Sinclair College
Building 14 – EMS Classrooms & Sim Lab
FAC 24-28X
Dayton, OH

ADDENDUM 01

Date of Addendum: January 31, 2025

This addendum consists of five (5) pages plus attachments.

LOWER LEVEL INTERIOR ELEVATIONS CONT.

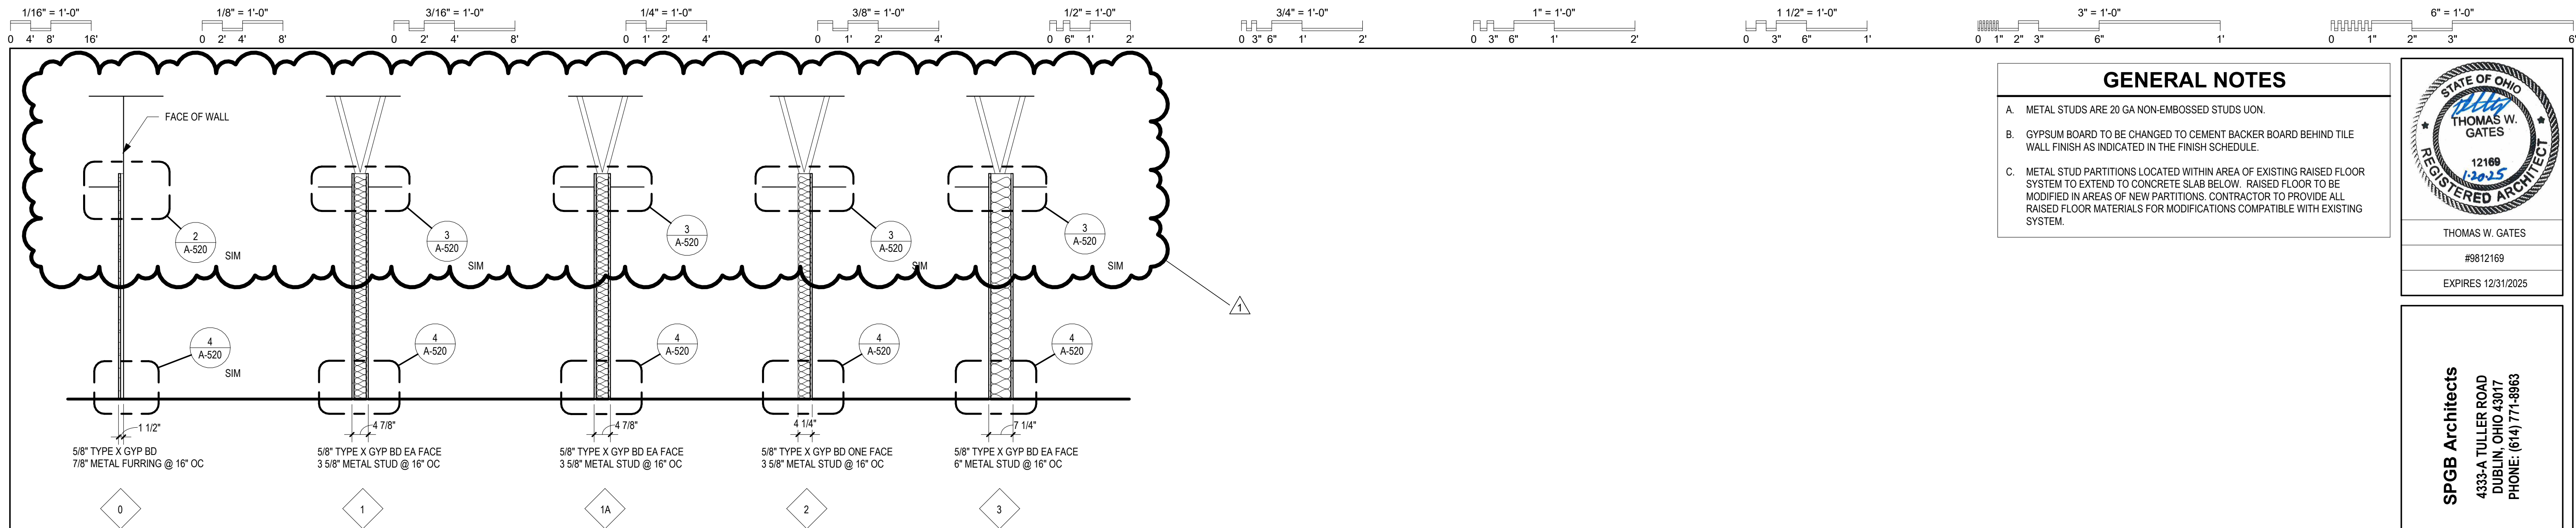
- a. Revise location of flat panel.
4. Sheet A-520 INTERIOR PARTITION TYPES:
 - a. Add detail 2/A-520 to partition type 0.
 - b. Add detail 3/A-520 to partition types: 1, 1A, 2, 3

1 PARTITION TYPES
 1/2" = 1'-0"

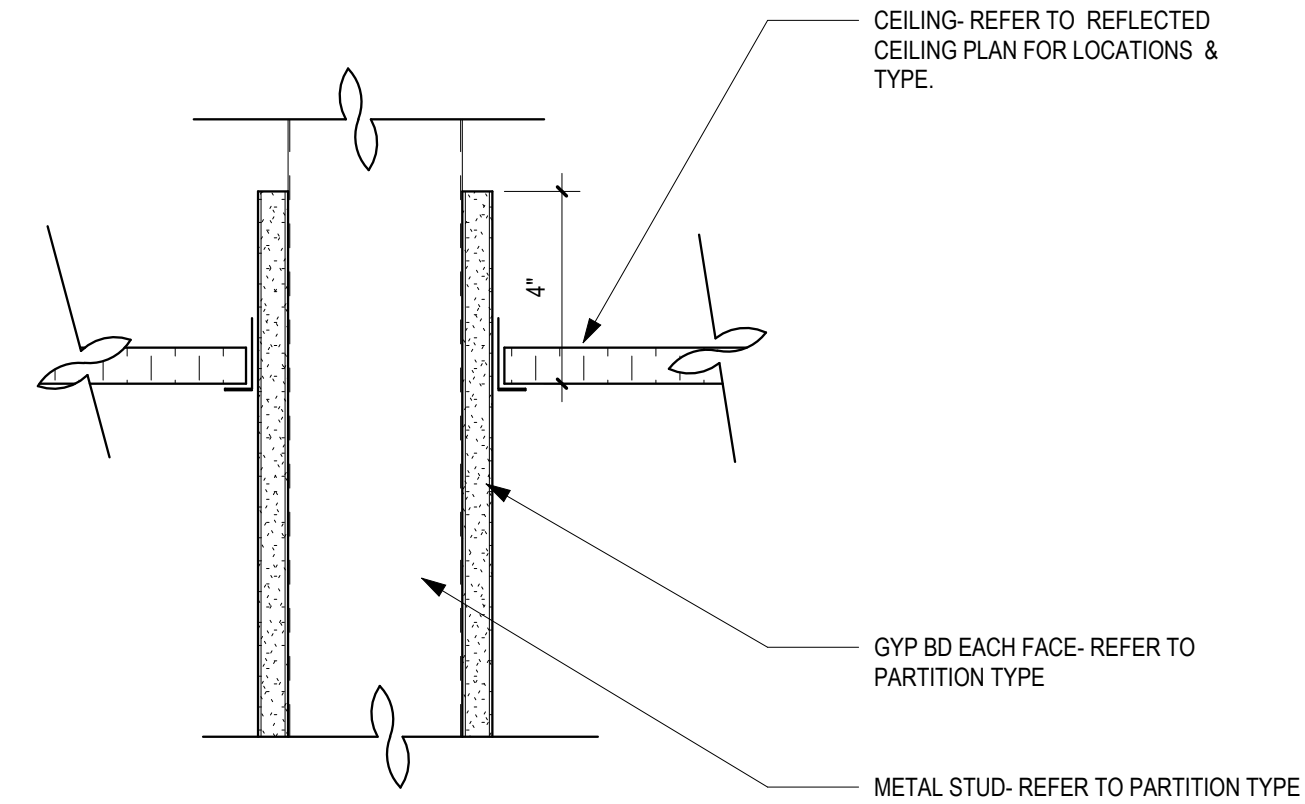
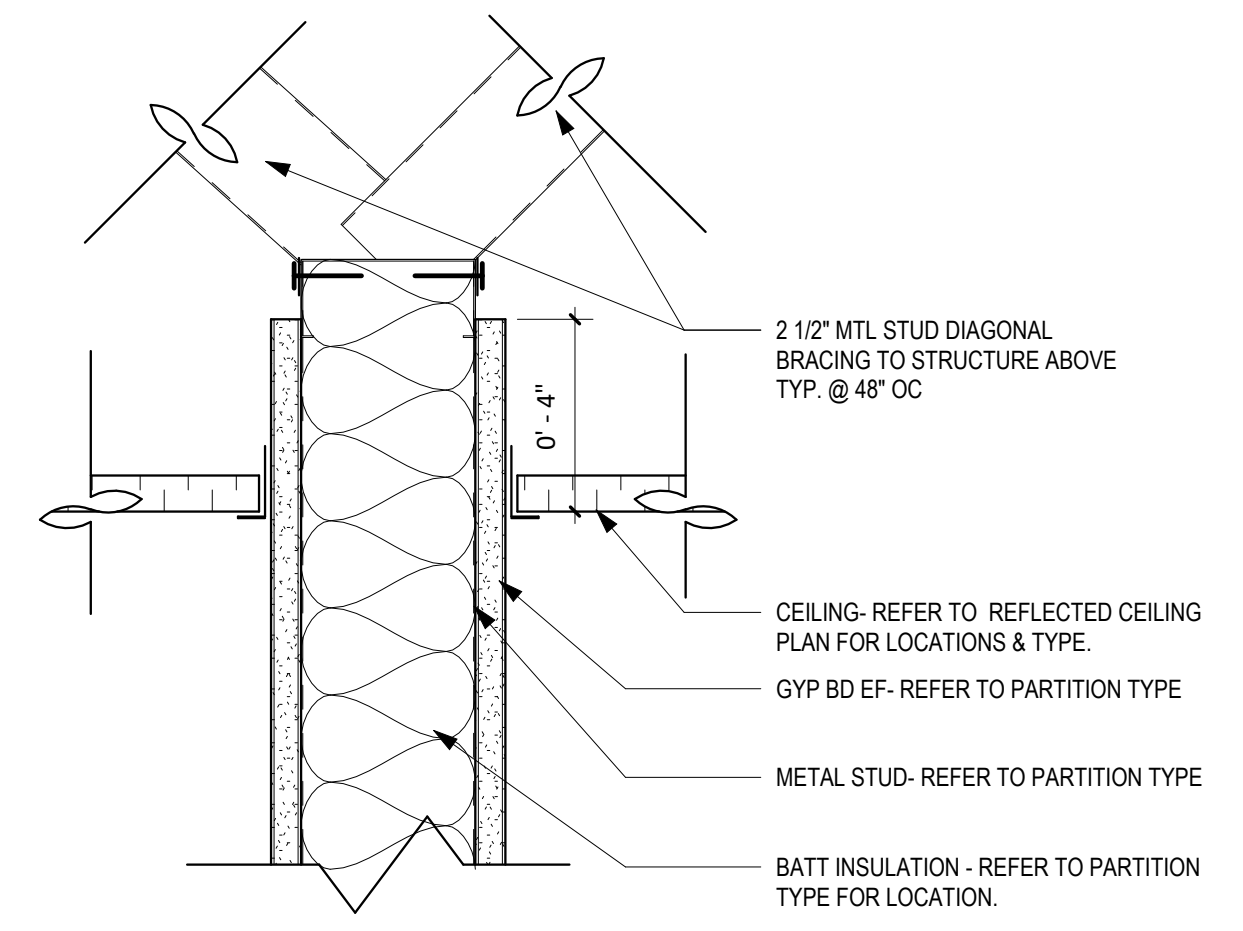
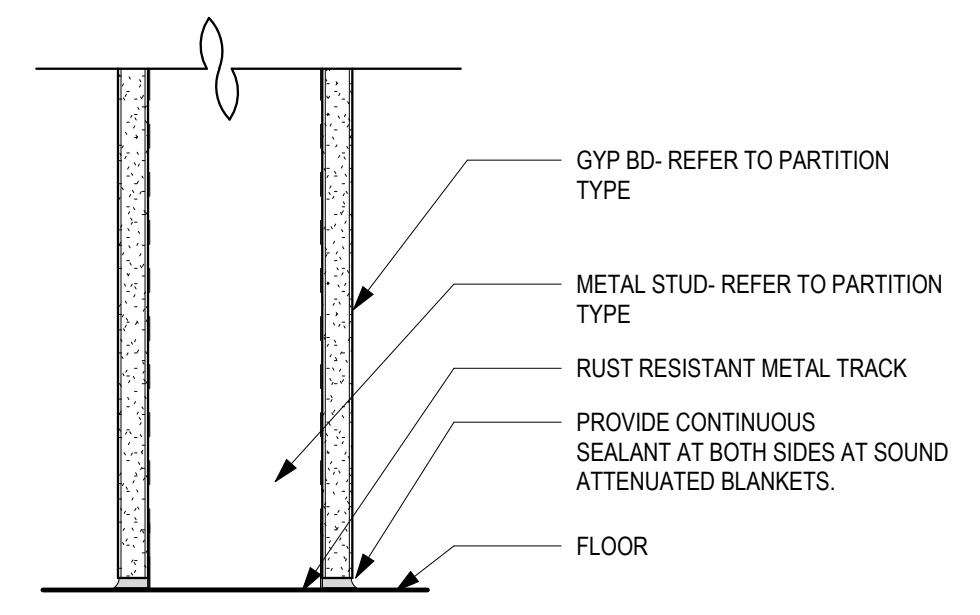
- I. During the meeting, it was noted that some partition types on sheet A-520 lacked reference details.
 - A. SPGB to revise Sheet A-520 INTERIOR PARTITION TYPES via Addendum 01.
